## ADDENDUM NO. 6

Reference: Holland Centennial Commons  
Dixie State College – St. George, Utah  
DFCM Project No. 06297640

## ADDENDUM NO. 7

## Addendum 007

**SHEET A111.3**  
**ADDENDUM #7**

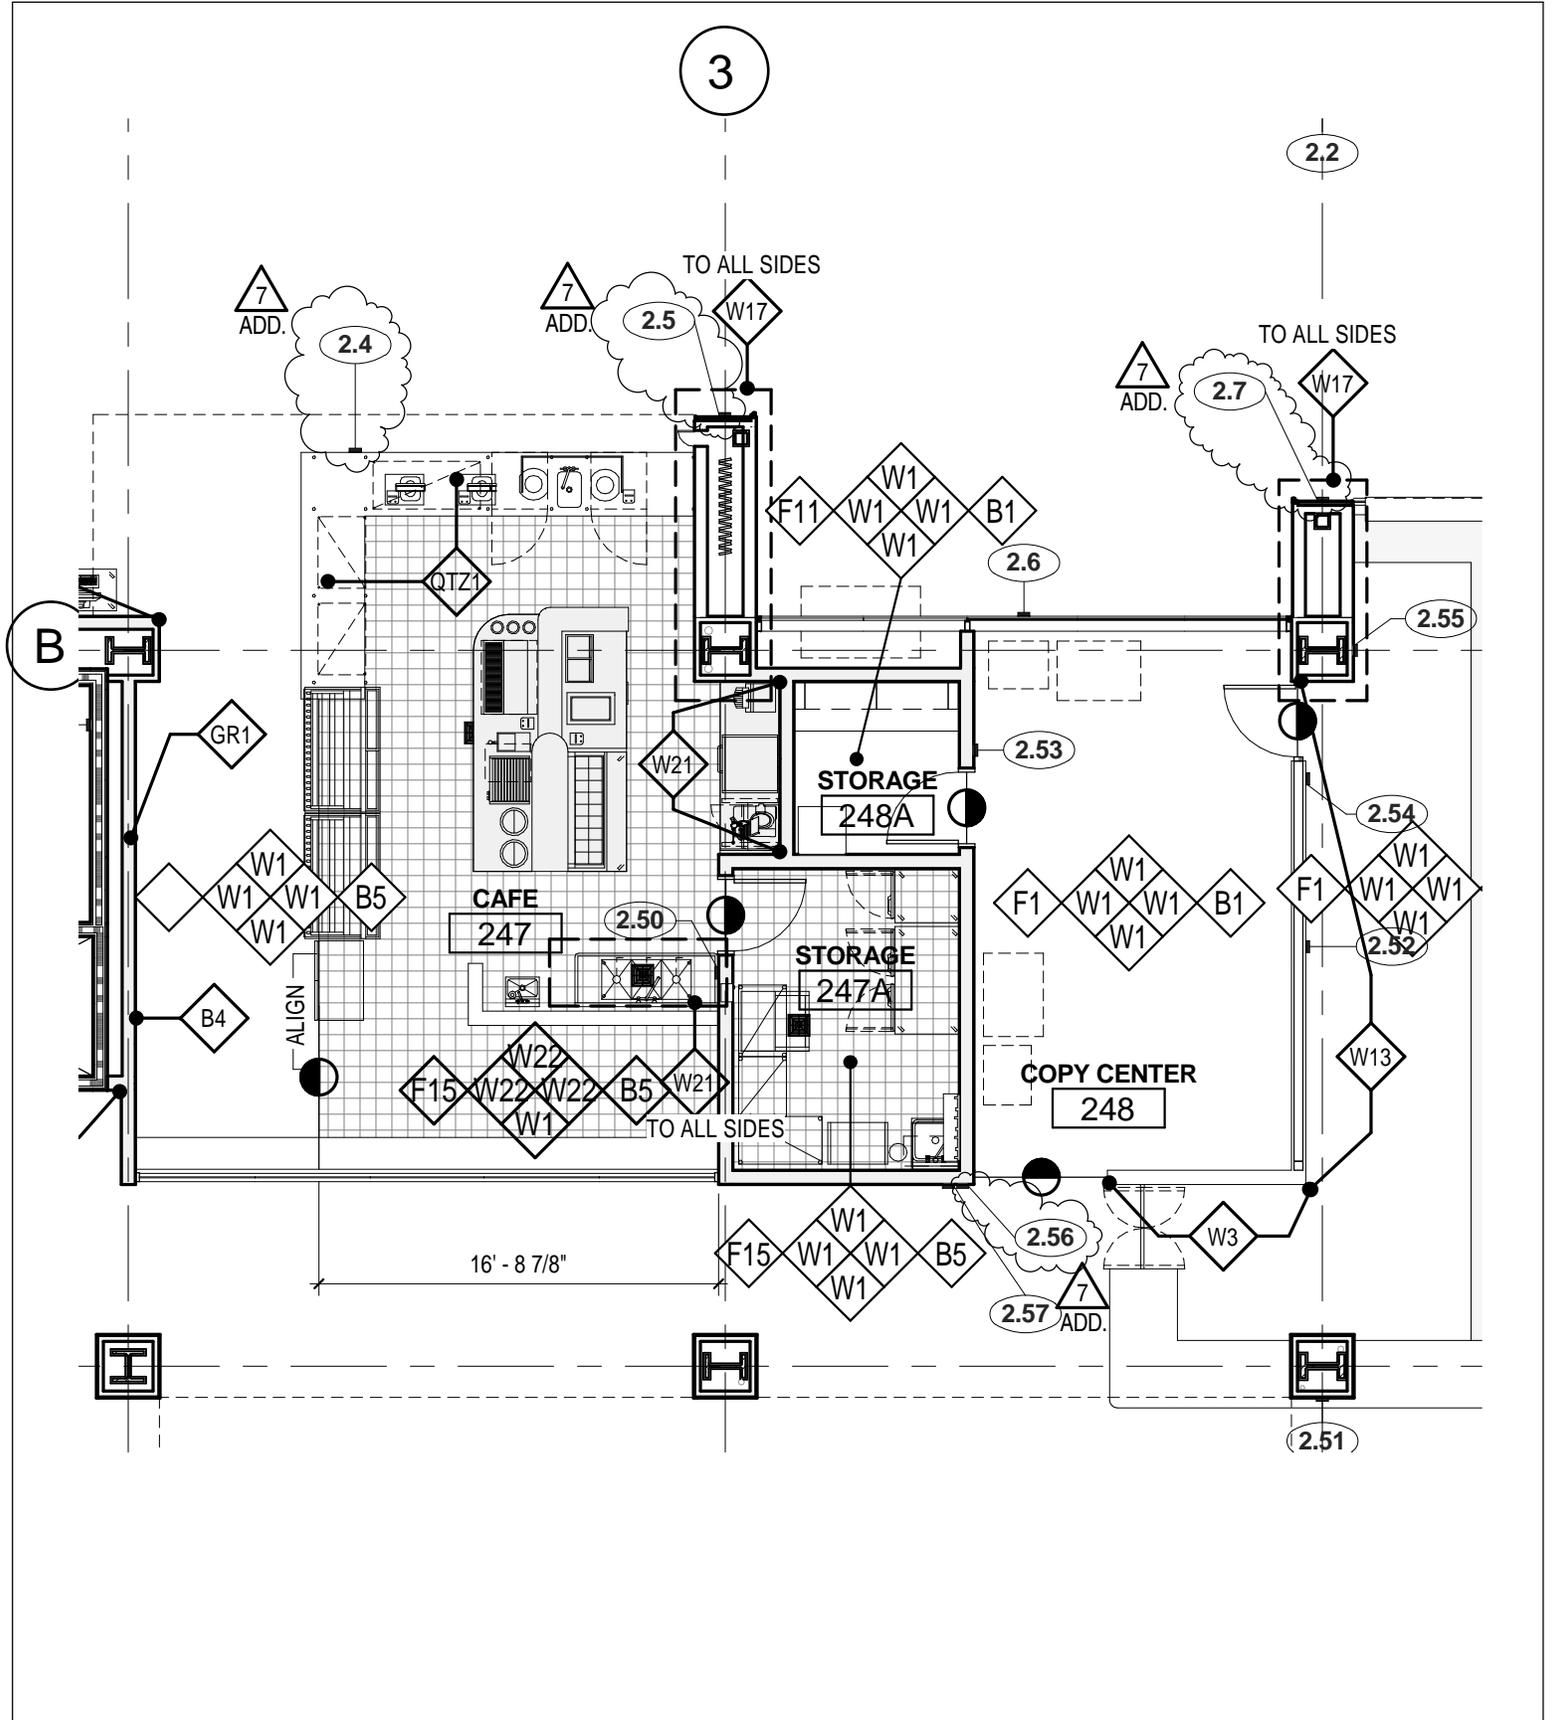
7.3	<p>SHEET A111.3</p> <p>Revise the following General Finish Notes:</p> <p>1 - Note #3 to read "All painted steel bracing and columns to receive W17" in lieu of "All painted steel bracing and columns to be painted XXX unless noted otherwise."  2 - Note #25: Delete  3 - Note #12 to read: "Provide tile W15: 4x4 ceramic wall tile at all janitor sinks. Provide tile bullnose to finish off all exposed edges." In lieu of "Provide tile XXX: 4x4 ceramic wall tile at all janitor sinks. Provide tile bullnose to finish off all exposed edges."  4 - Note 16 to read: "All hollow metal door frames to receive W16." in lieu of "All hollow metal door frames to be XXX."</p> <p>Revise the following Finish Legend Notes:</p> <p>5 - Add finish W21 "tile" to the finish legend  6 - Level 1 lobby 125: Finish tag addressing base finish to read B6 in lieu of B4.  7 - Level 1 public hallway off the elevator lobby 103: Finish tag addressing base finish to read B6 in lieu of B4.  8 - Mechanical 116: Finish tag addressing base finish to read B1 in lieu of B2.  9 - Concession Stand 126: Finish tag addressing wall finish to read W21 in lieu of W22 north, south east and west wall.</p> <p>Revise the following Sign Call-Outs:</p> <p>10 - Add the following signs: 1.15, 1.87, 1.90, 1.91, 1.93, 1.102, 1.103  See the attached sheets for locations.</p>

**SHEET A121.3  
ADDENDUM #7**

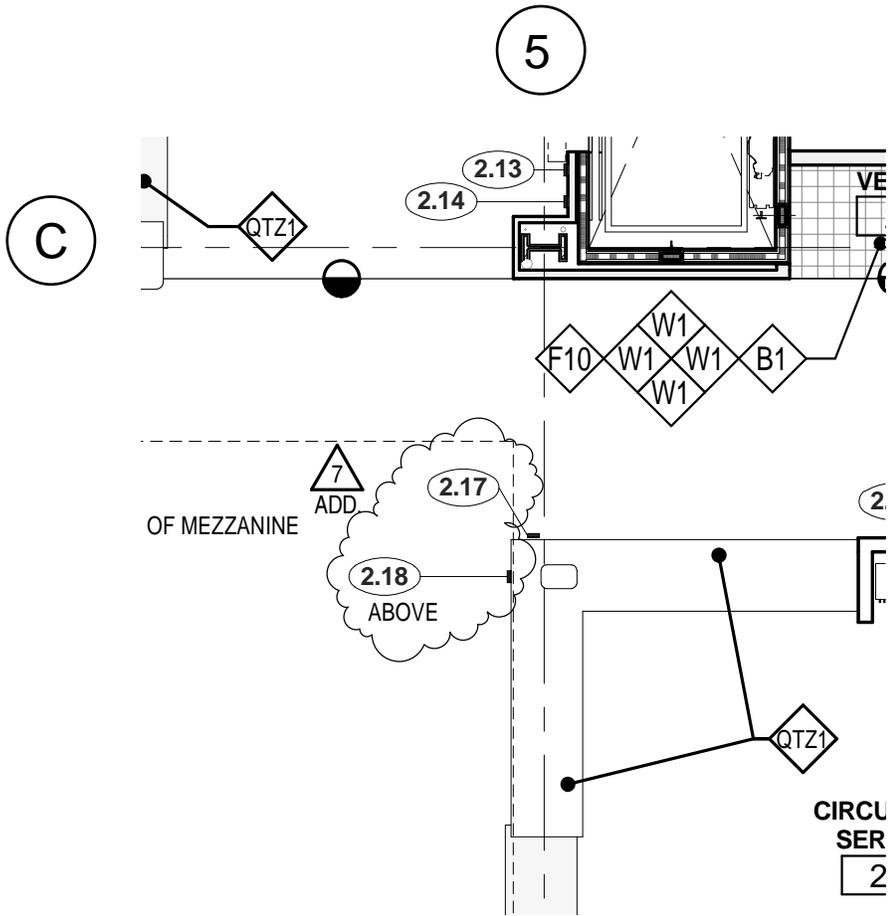
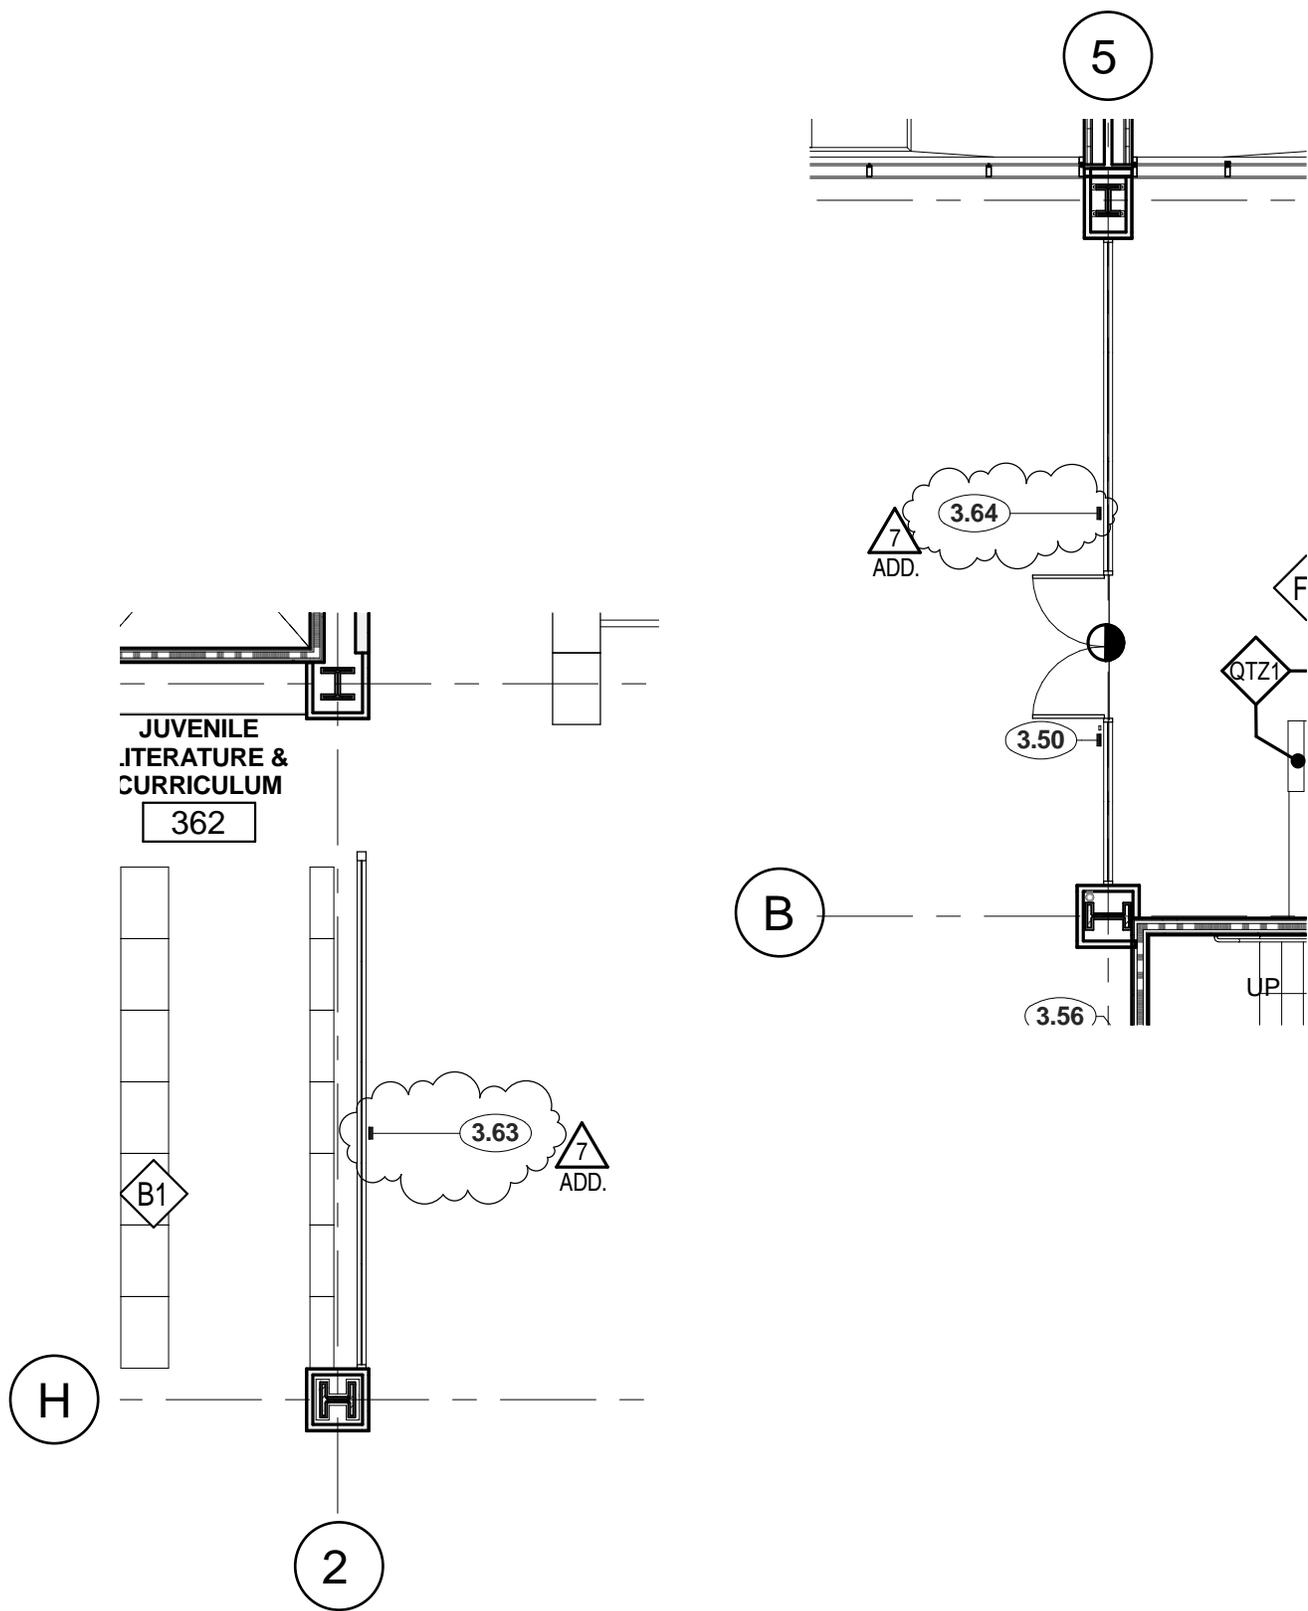
7.4	<p>SHEET A121.3</p> <p>Revise the following Finish Notes:</p> <p>1 - Level 2 lobby 219: Finish tag addressing base finish to read B6 in lieu of "-".  2 - Dixie Heritage: Finish tag addressing base finish to read B6 in lieu of B4.  3 - Café 247: Finish tag addressing wall finish to read W21 in lieu of W22 north, south, east and west wall.  4 - Library 235: At elevator lobby 203, The wall between the monitor and column to receive graphic GR1.  5 - Library 234: Finish tag addressing the wall finish to read W3 in lieu of W1, north wall.</p> <p>Revise the following Sign Call-Outs:</p> <p>6 - Add the following signs: 2.4, 2.5, 2.7, 2.18, 2.56  See the attached sheets for locations.</p>

**SHEET A131.3  
ADDENDUM #7**

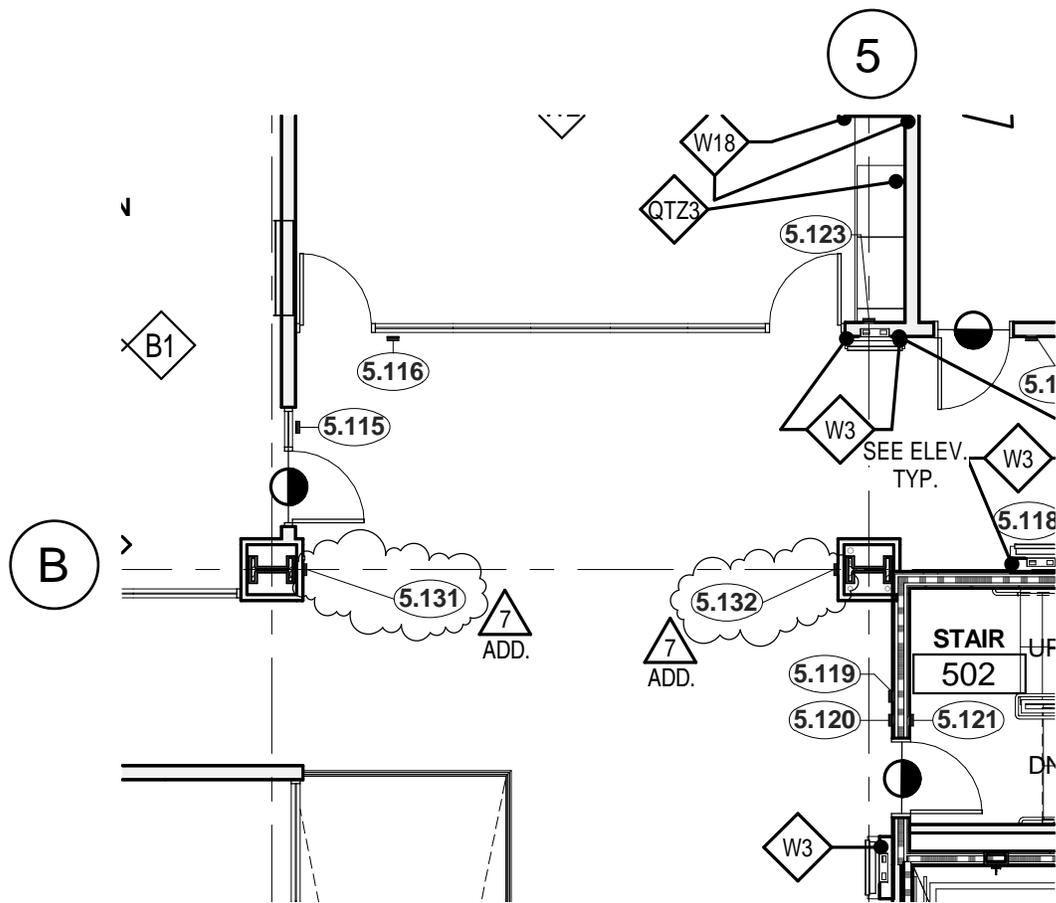
7.7	<p>SHEET A131.3</p> <p>Add the following Sign Call-Outs: 3.63, 3.64. See the attached sheets for locations.</p>
7.8	<p>SHEET A151.3</p> <p>1 - Circulation 576: Furred out wall below monitor to receive W3 all sides.</p> <p>2 - Add the following Sign Call-Outs: 5.131, 5.132. See the attached sheets for locations</p>

**Sheet L101 PLANTING PLAN**

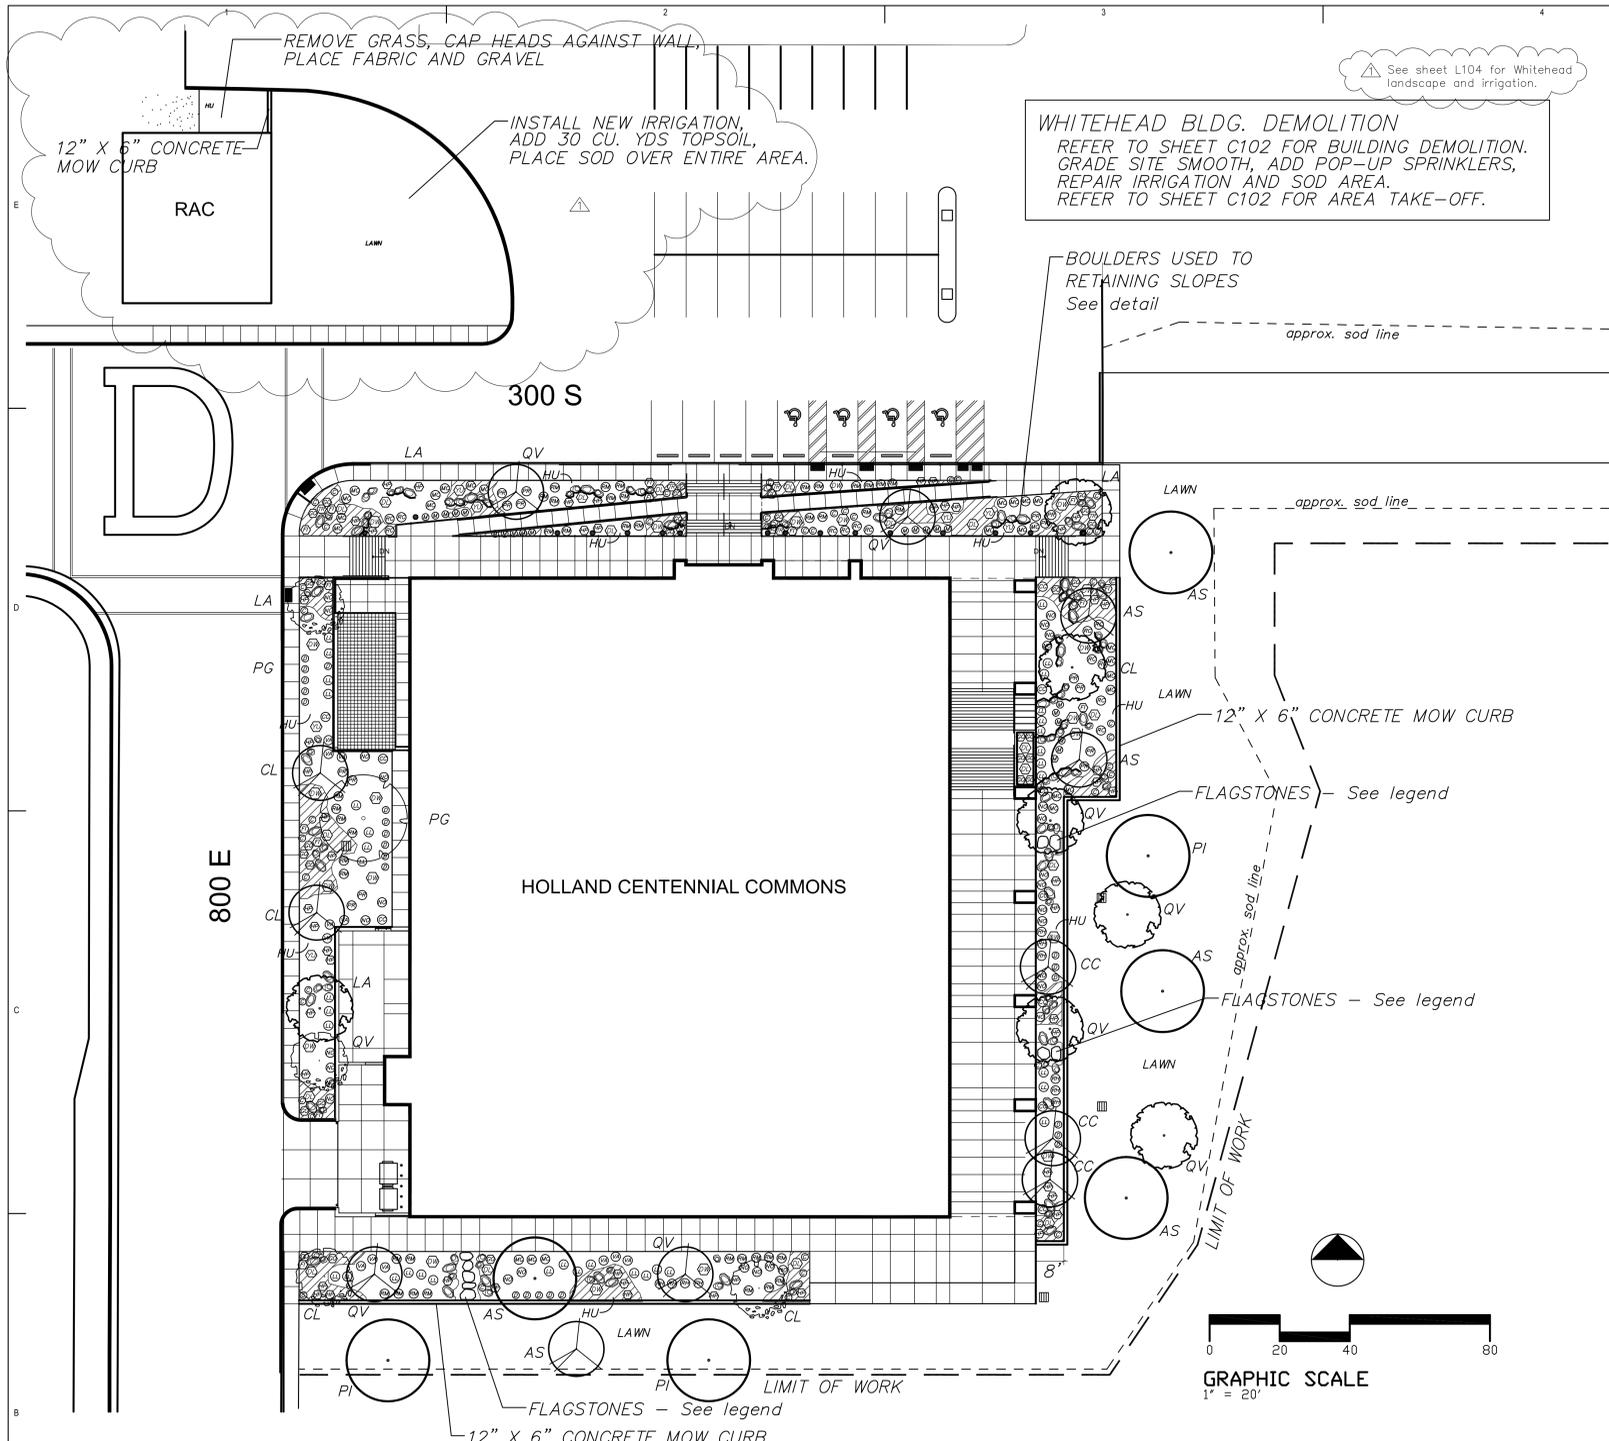
1. Add Aleppo Pine to plant legend.
2. Add RAC bldg. landscape.
3. Add approximate edge of sod line along each side of fire lane.
4. Add notes to refer to sheet L104 for Whitehead bldg. landscape.
